**STATE OF HAWAII
DEPARTMENT OF TRANSPORTATION
AIRPORTS**

**ADDENDUM NO. 3
FOR
MKK TERMINAL BUILDING ROOF REPLACEMENT
MOLOKAI AIRPORT
HOOLEHUA, MOLOKAI, HAWAII
STATE PROJECT NO. CM2521-33**

June 10, 2026

DATE :	DWG. NO.
DEC 19, 2025	S102
SHEET :	
19 OF 30 SHTS

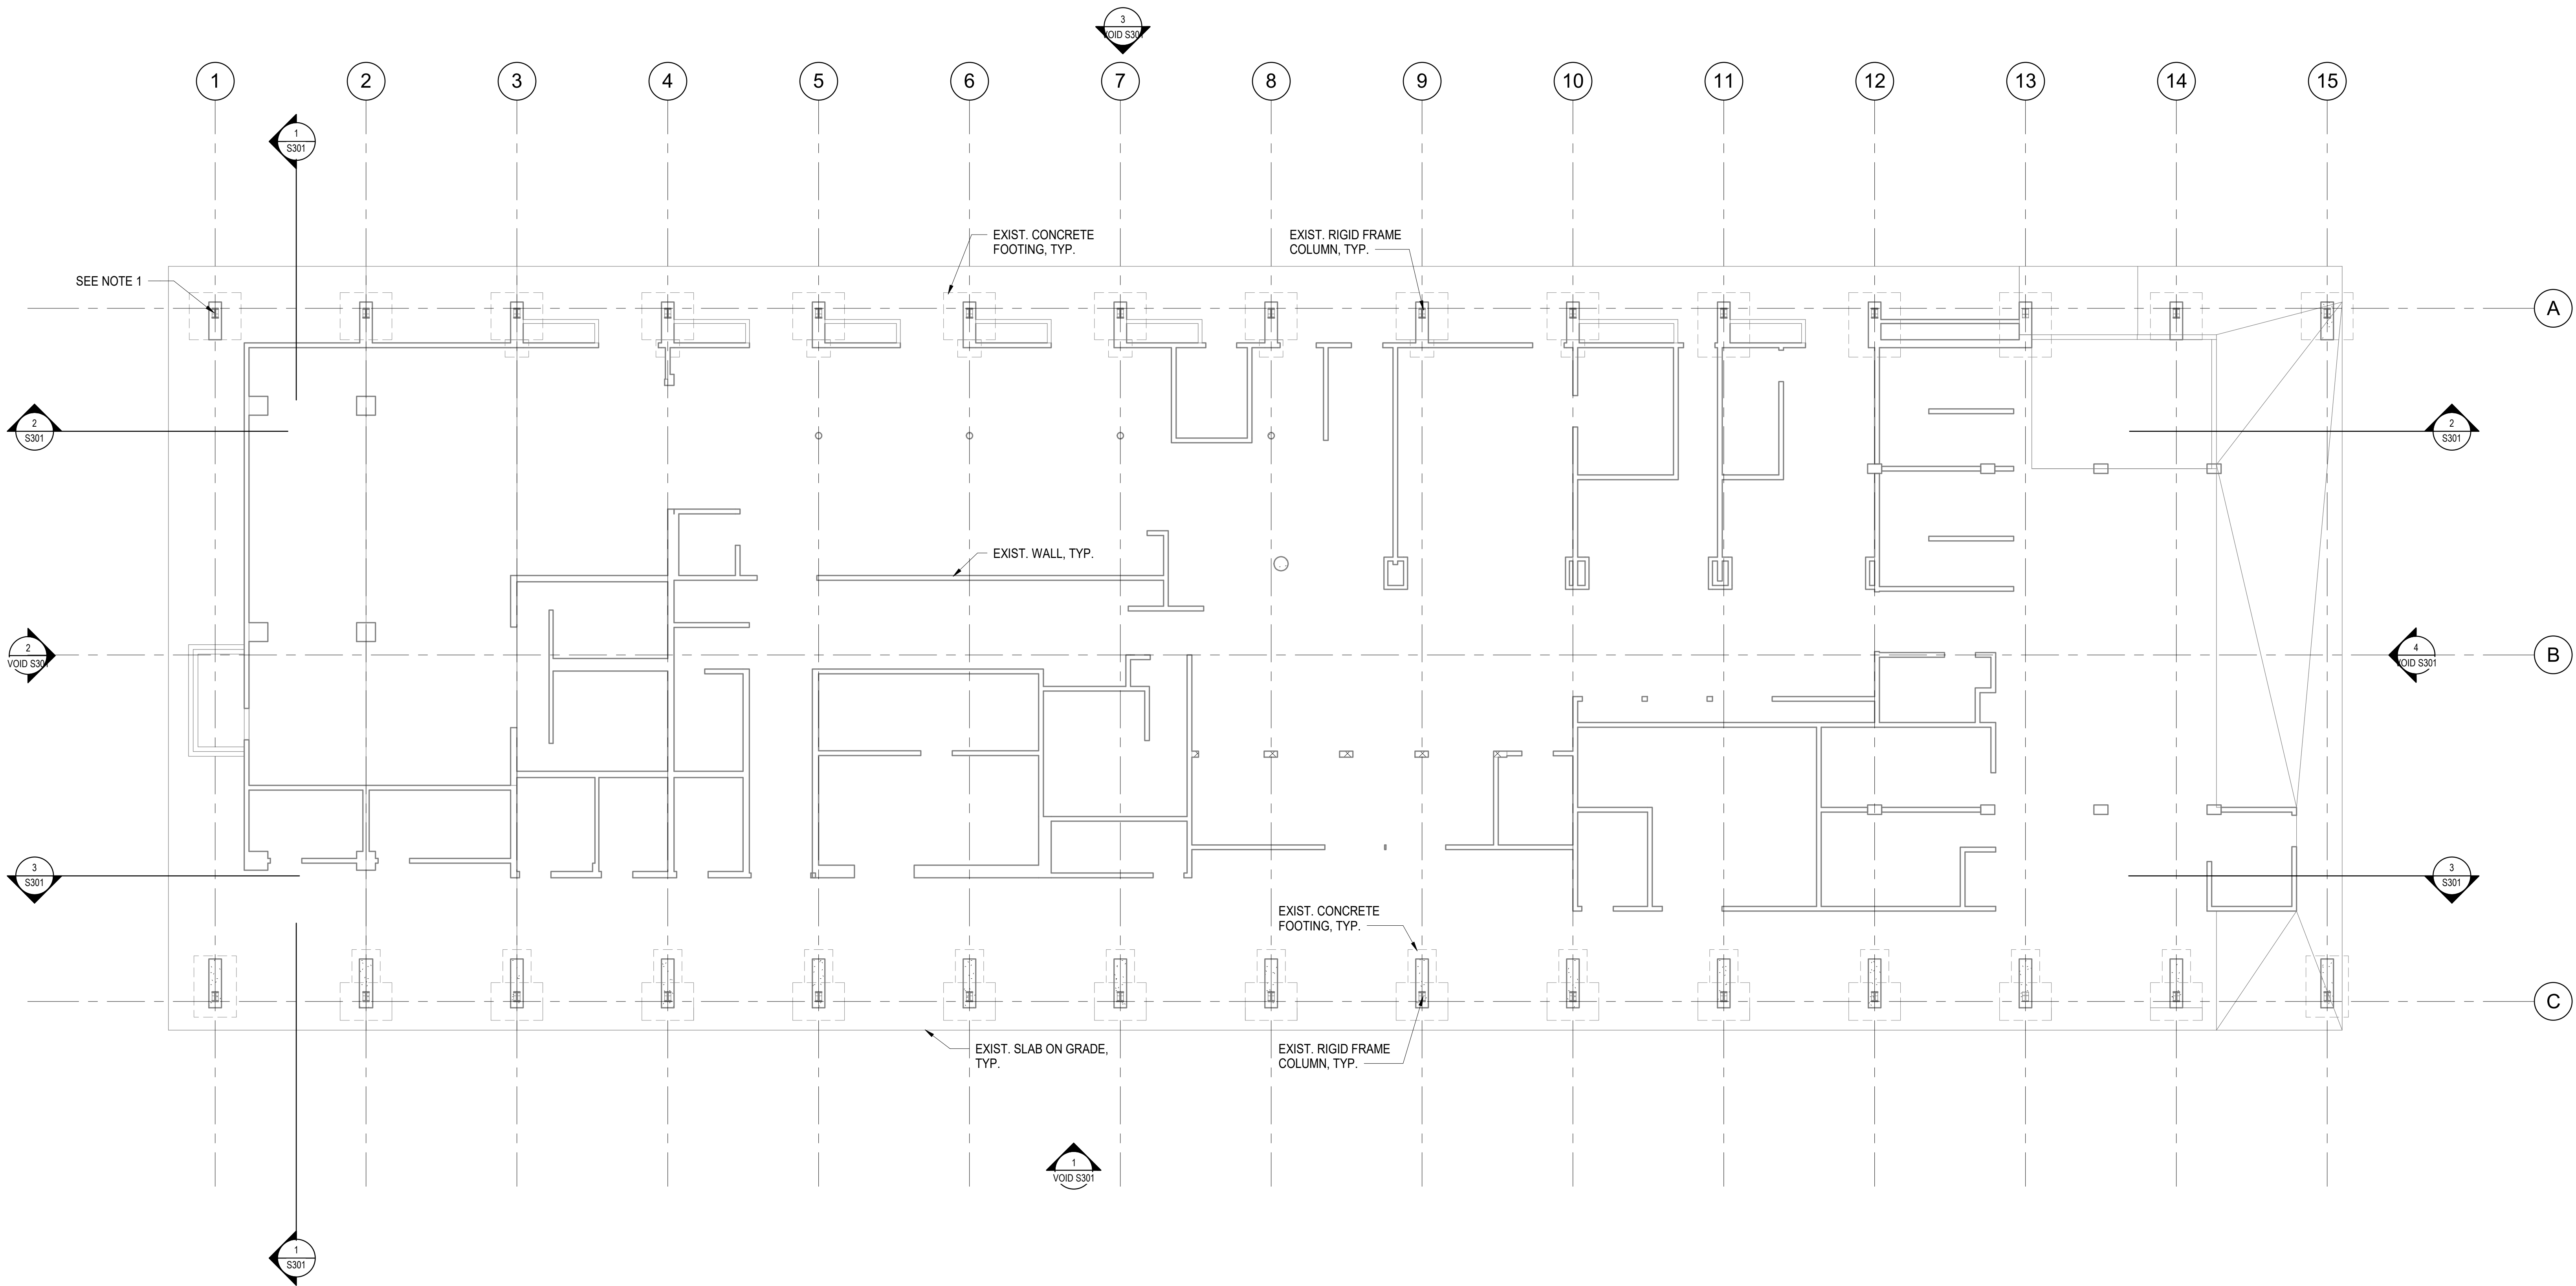
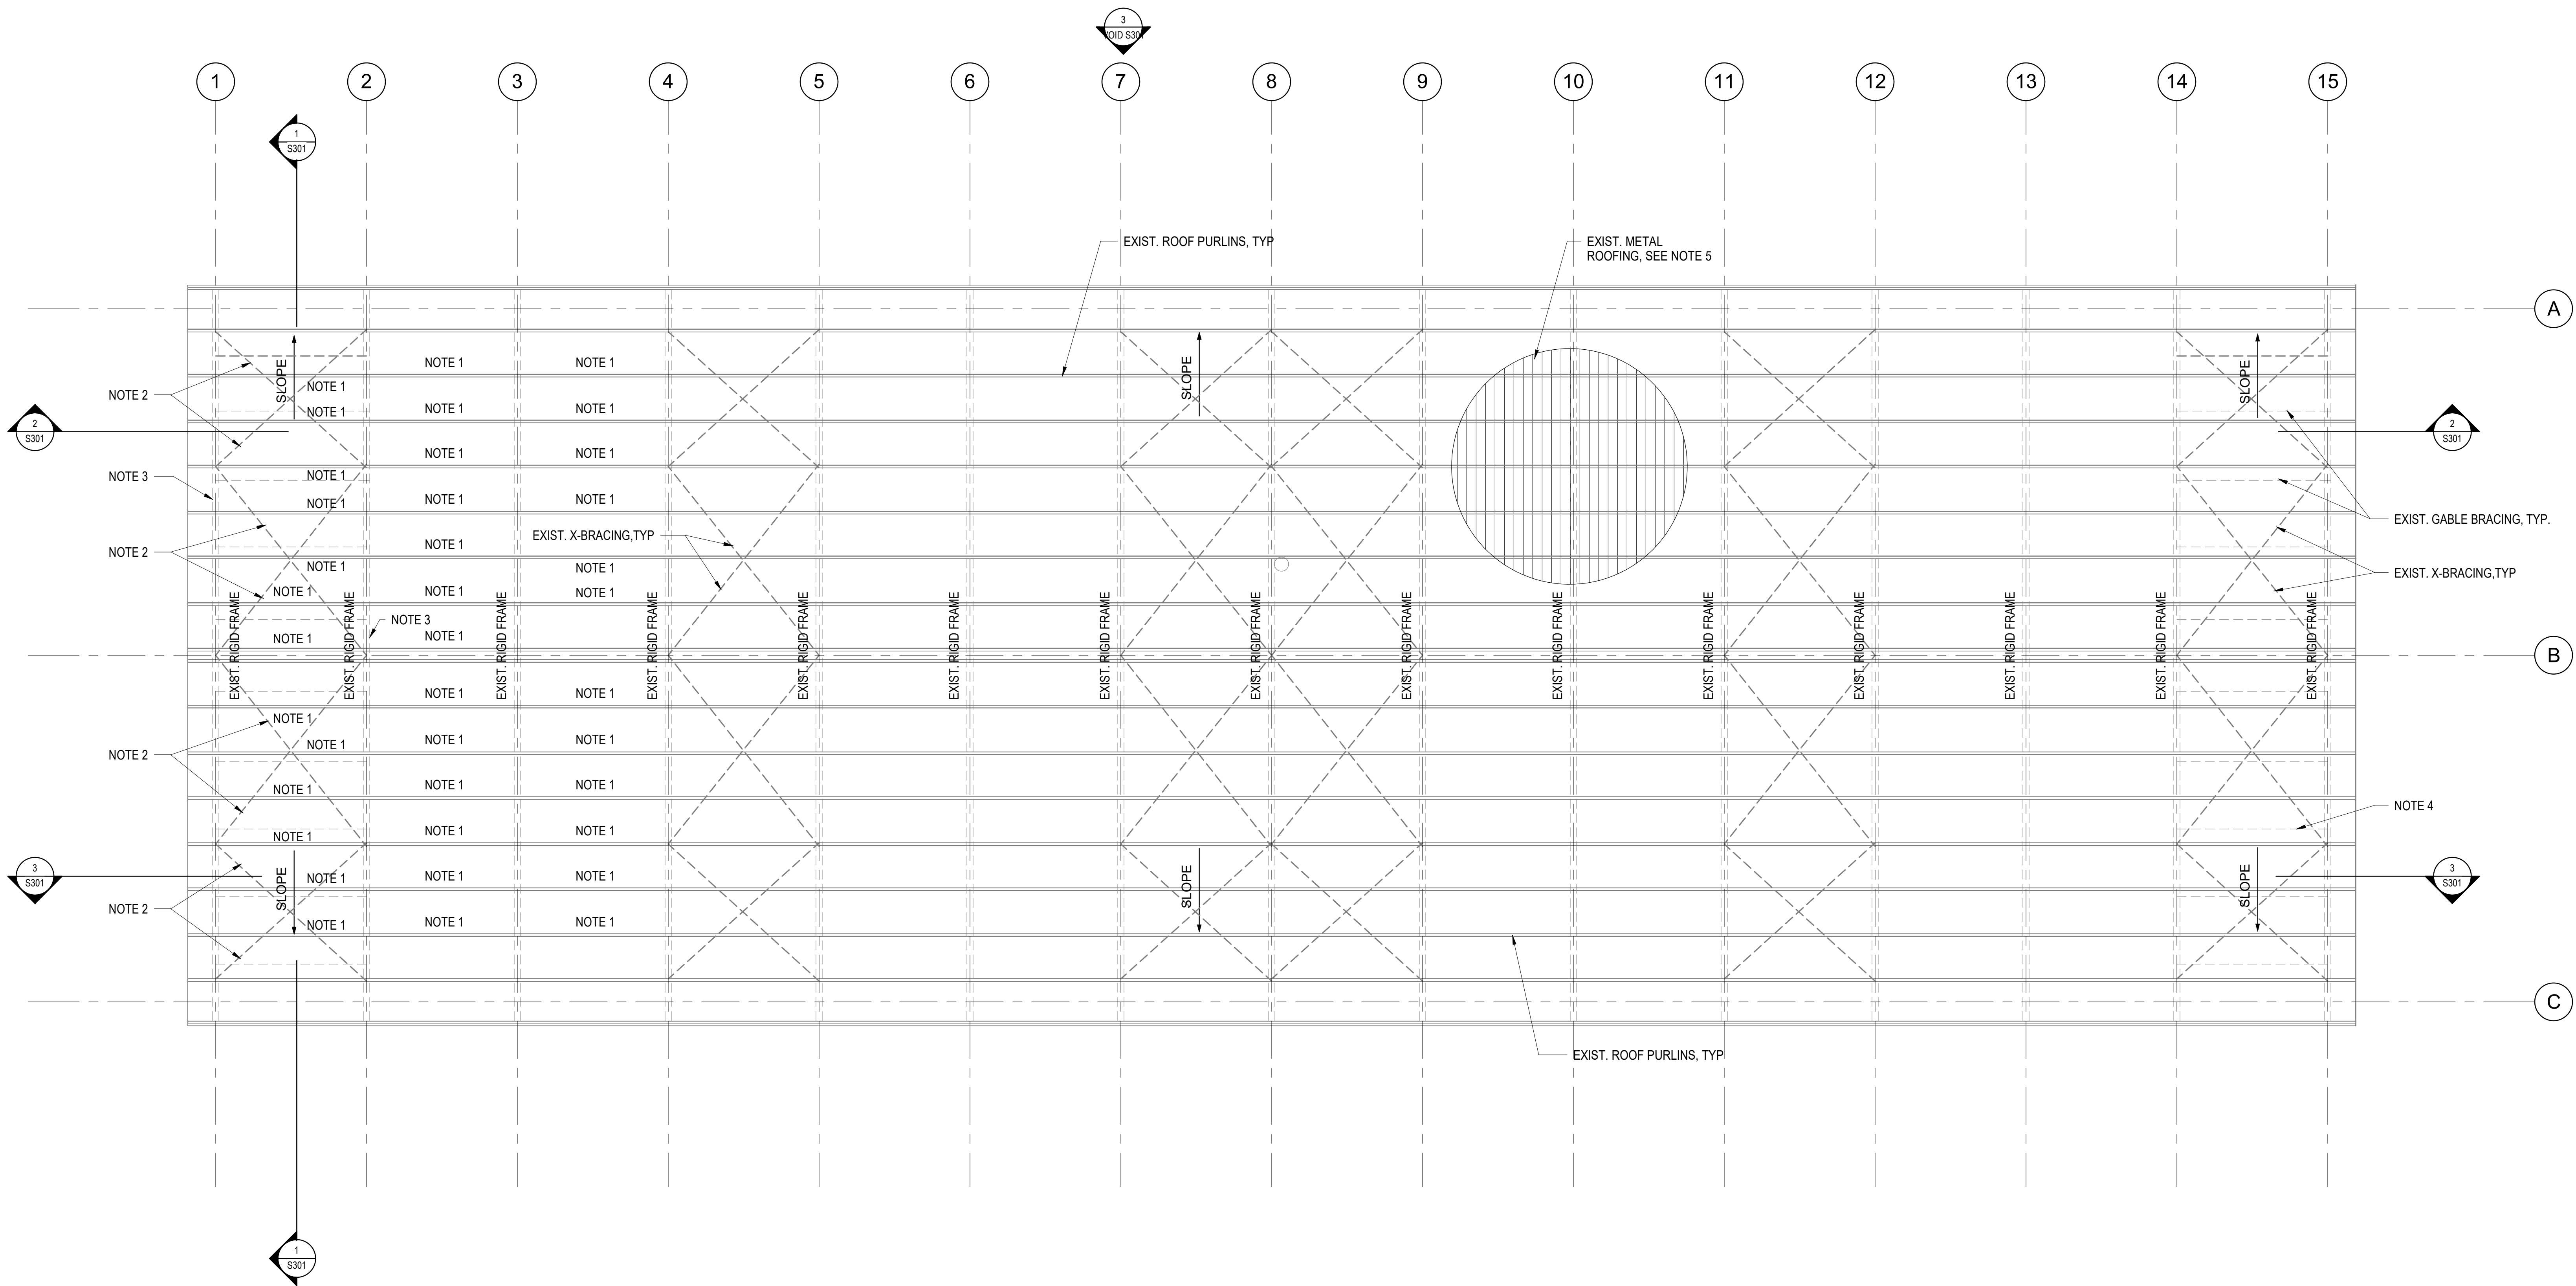
Structural plan sheet S102, identifies one gable brace on the east side that should be replaced.
